Los Angeles International Airport Community Noise Roundtable

LAX Departure Overflights of Palos Verdes and San Pedro

Comments by Jeff Calvagna

6 March 2018

OSHNN8 Standard Instrument Departure (SID)

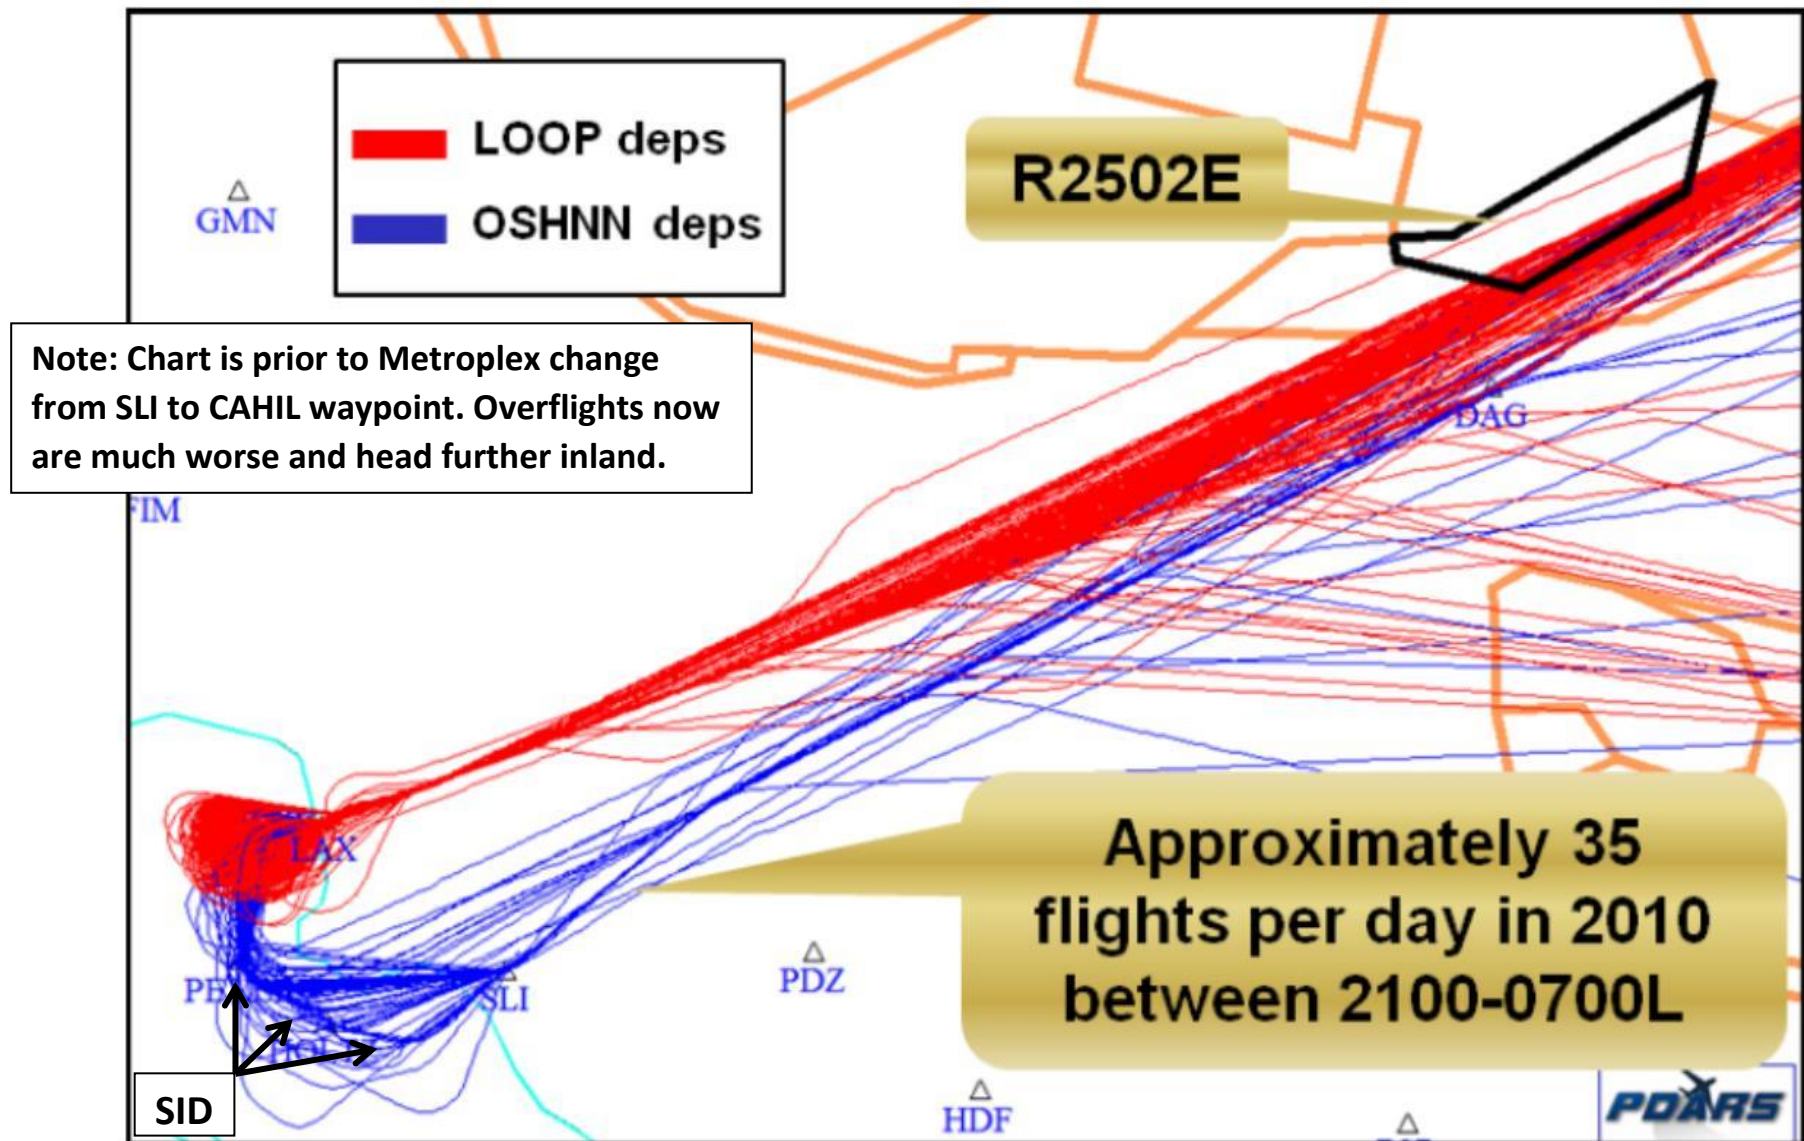
Source of Most Palos Verdes and San Pedro Overflights

OSHNN SID designed for noise abatement yet ATC routinely shortcuts noisy departures over PV and San Pedro Residential Neighborhoods

OSHNN SID Adherence
Typical patterns observed Jan-Feb 2018

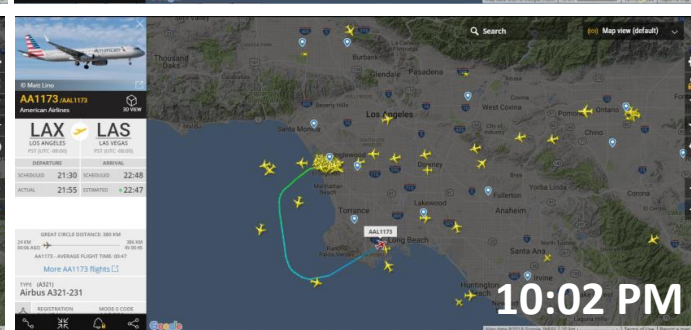
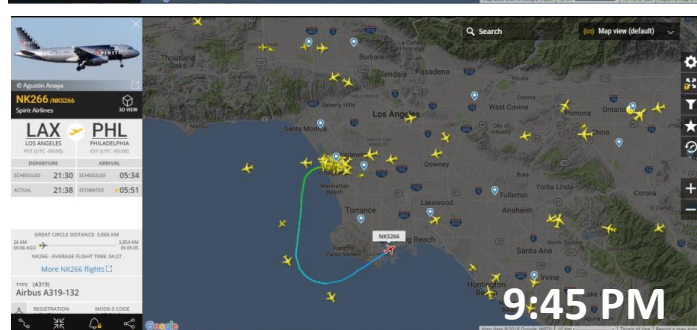
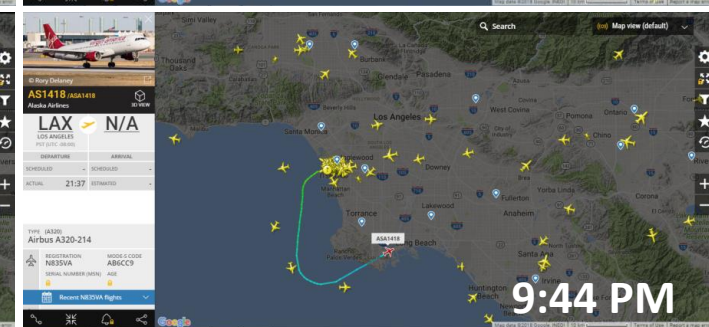
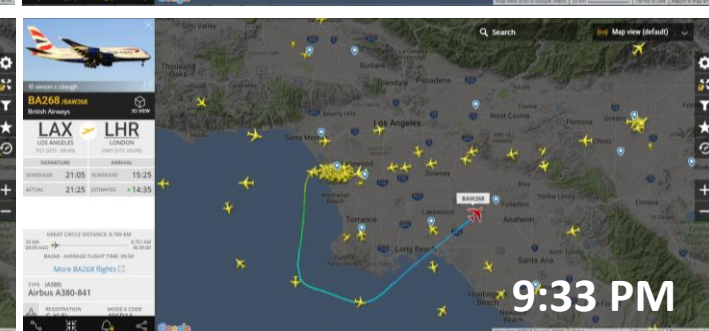
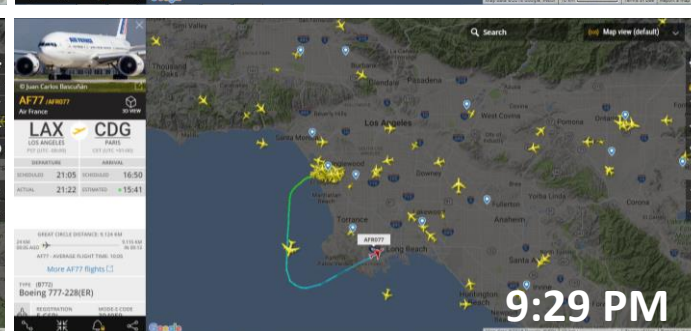
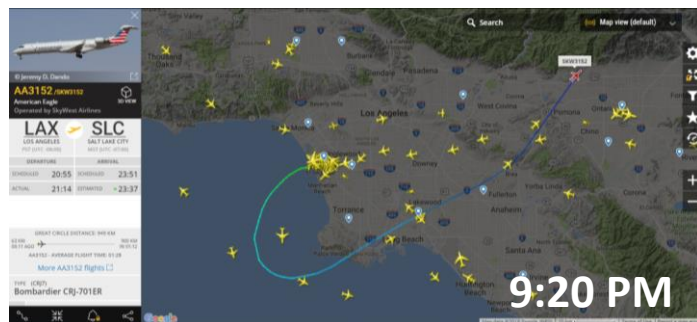
Over 70% of OSHNN Departures shortcut over/near the PV Peninsula

Percentage of flights assigned OSSHNN that fly the SID versus those that shortcut over PV

GREEN – Adhere to the SID (20%)
YELLOW – HOLTZ shortcut (20%)
RED – PEVEE shortcut (60%)

FAA claims OSHNN is the “standard” departure to satisfy noise abatement requirements but doesn’t follow its own documented procedures

OSHNN Shortcuts – Jan 19th, 9:20 PM to 10:02 PM

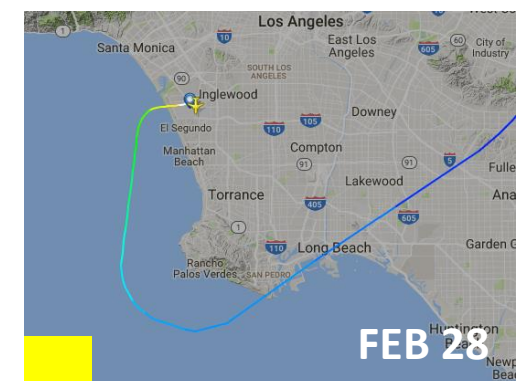
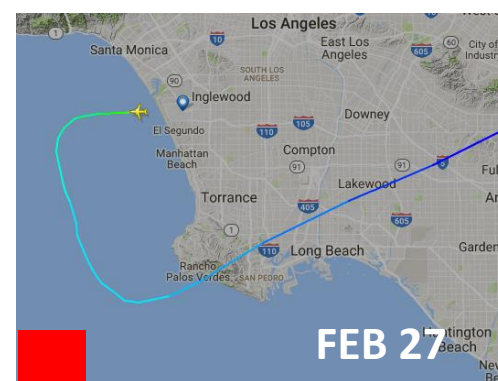
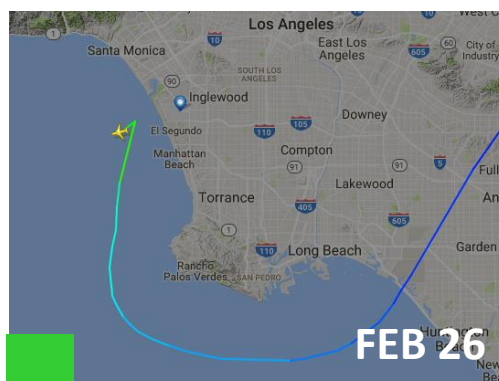
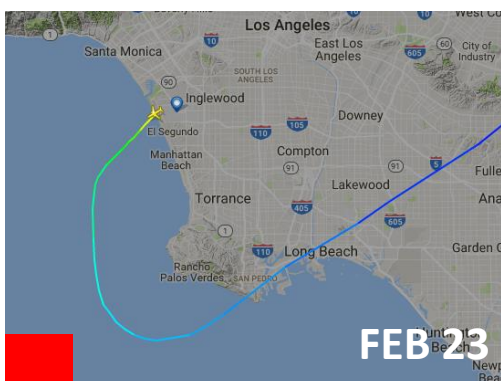
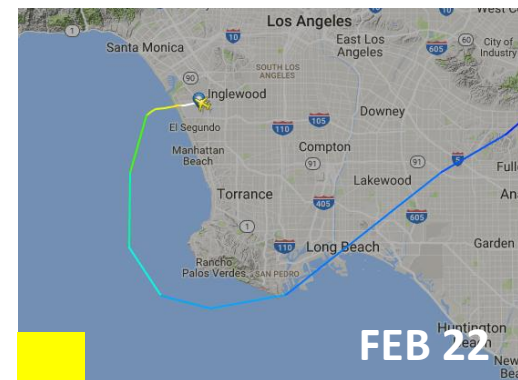
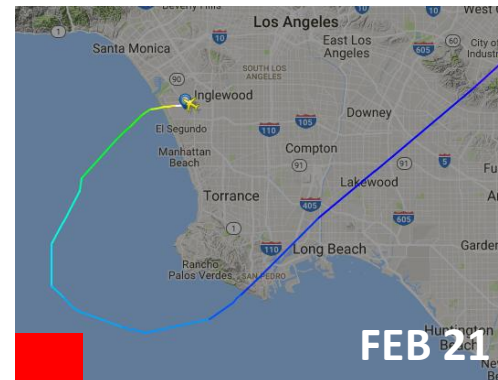
During this evening period, not a single flight correctly flew the SID, all shortcut over or near Palos Verdes

During peak OSHNN usage aircraft can overfly PV every 2-3 minutes

Case Study – Southwest 1283 (LAX → LAS, 9:23 PM Departure)

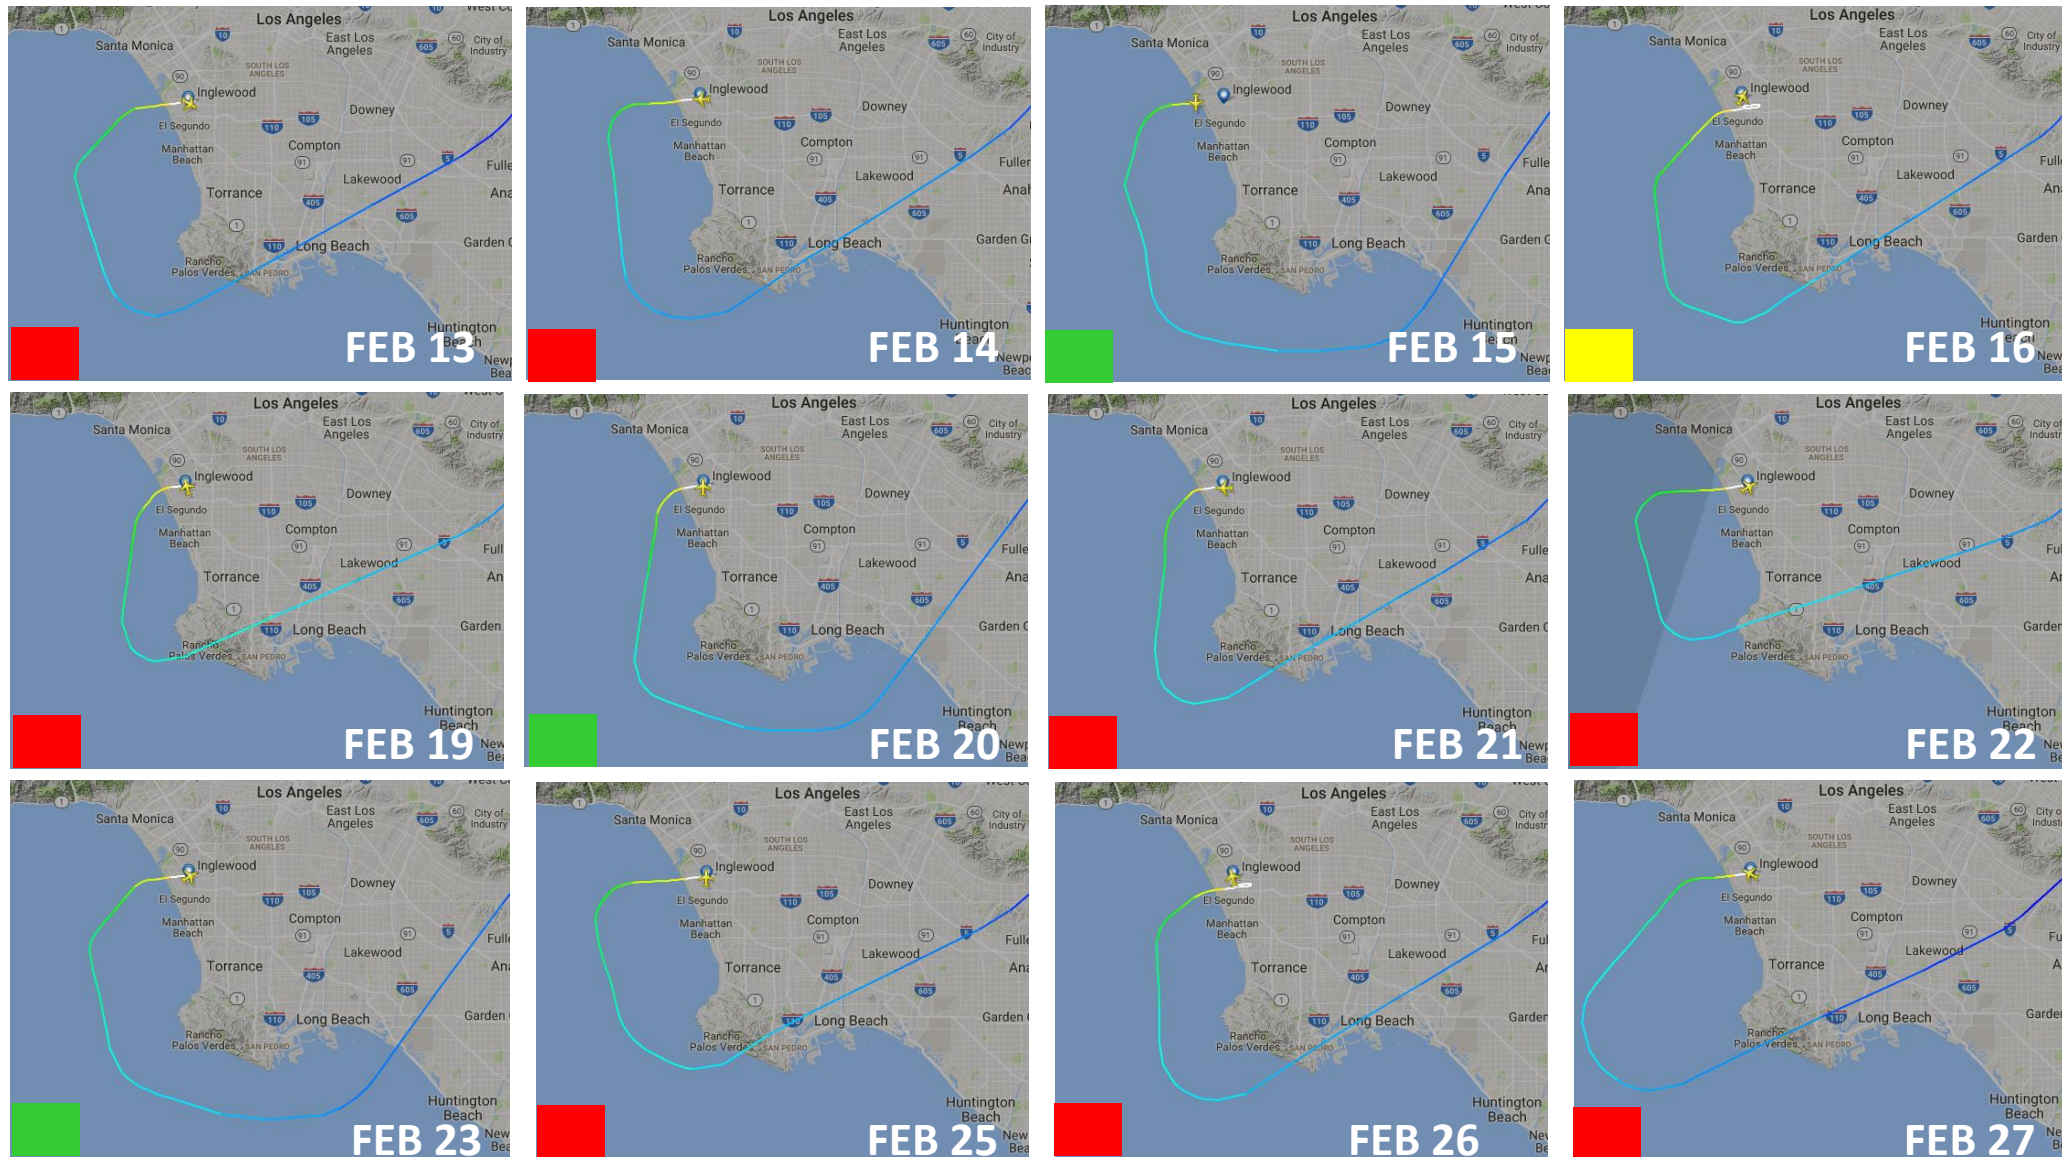
Out of 12 flights, 8 overflowed Palos Verdes/San Pedro (67%)
2 flew the SID (green), 2 HOLTZ shortcut (yellow), 8 PEVEE shortcut (red)

Why is This Happening? (ATC Vector “Direct to CAHIL”)

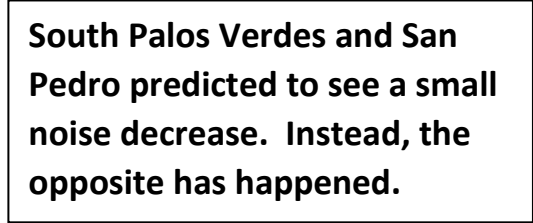
Why would ATC and pilots want to shortcut the OSHNN SID?

- OSHNN is longer and takes more time – particularly if the aircraft had originally filed for the ORCKA (loop) departure
- OSHNN is complex and slower – three turns, at PEVEE, HOLTZ, and OSHNN
- OSHNN is busy – PEVEE to OSNNH leg shared with the DOTSS departure
 - More ATC intervention needed to de-conflict with DOTSS traffic
 - Speed restrictions often needed to maintain separation
 - Altitude restrictions due to Long Beach (LGB) southern departures
- OSHNN delays ATC hand-off from SoCal TRACON to LA Center (ZLA)

Since there is no PV air traffic, “Direct to CAHIL” is a free pass SoCal TRACON uses to make these concerns go away, rarely is it “required for spacing”
